## **REMARKS**

Claims 1, 5, 6, 10, 11, 15, 16 and 20 are pending. Claims 1, 5, 6, 10, 11, 15, 16 and 20 are rejected.

*Figure 2*  
*Prior Art*

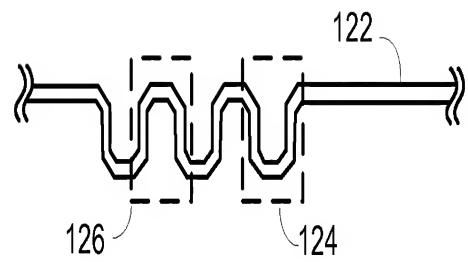
Examiner has objected to the disclosure because reference labels 120, 130, and 140 require a corresponding description in the specification. Figures 2 and 3 have been revised to remove reference numerals 120 and 130. Paragraph [024] of the Specification has been amended to include reference numeral 140.

*Figure 4*

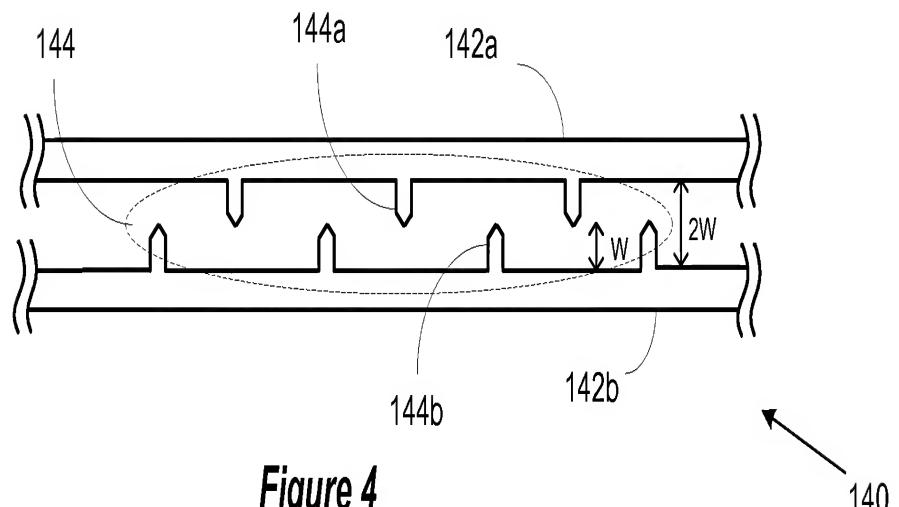
Replacement drawings sheets for Figures 4 and 5 are submitted to overcome Examiner's objections. Figure 4 has been amended to show reference numerals 144 and "W." Figure 5 has been amended to show "3W" for the trace spacing.
